Certificate of Appropriateness

Property 2008 N. 2ND ST. Brewers Hill

Date issued 4/13/2020 PTS ID 114929 COA: new garage on existing slab

Garage elevations and details. Gable vents must be added as shown. Overhead door may be as shown here or as on following page. Roof pitch shall be within the range of 7/12 to 8/12 inclusive.

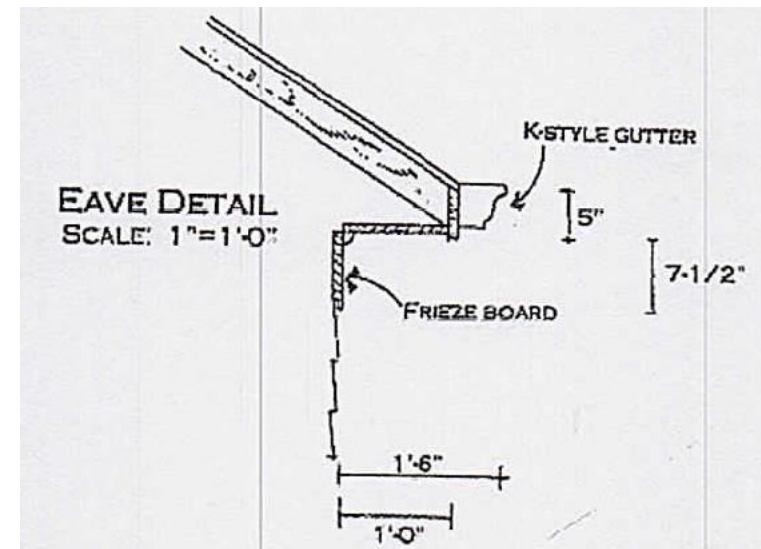
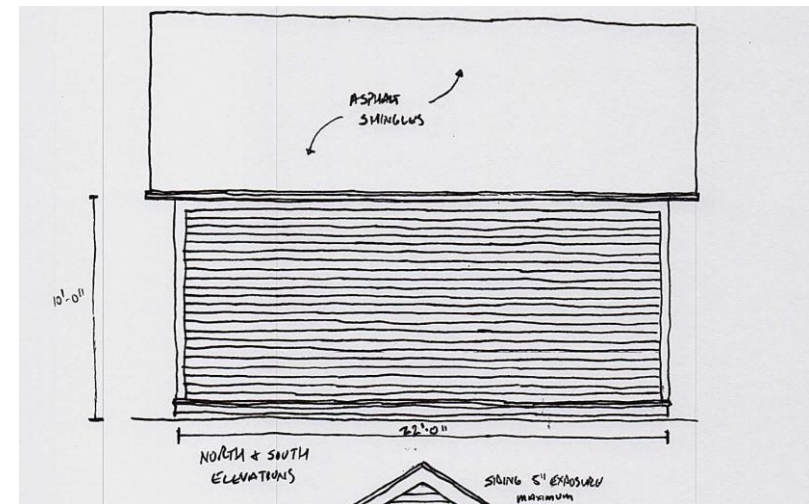
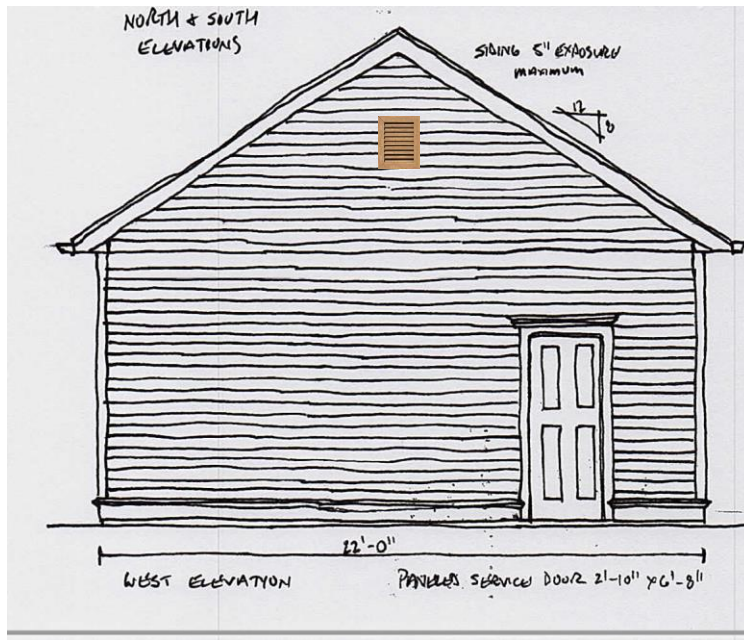
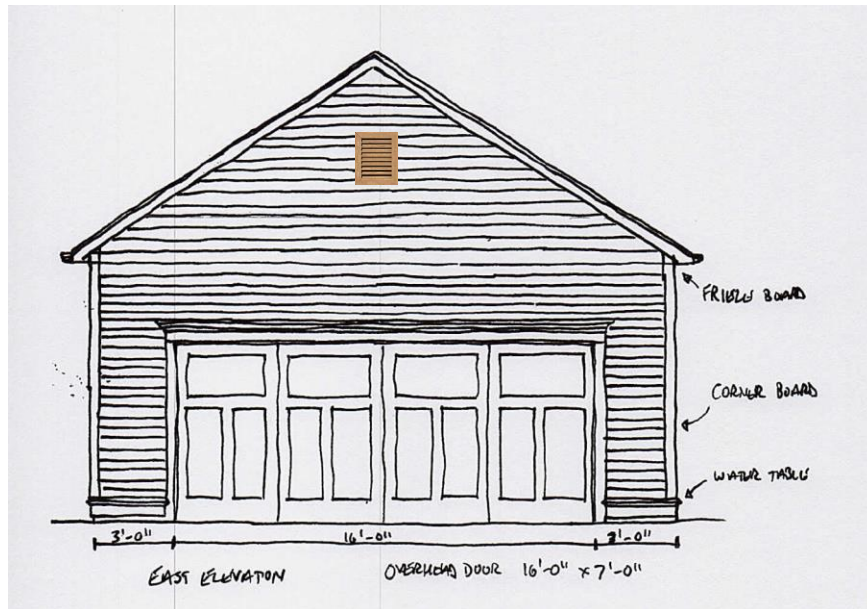
Do not use this steel panel door style.
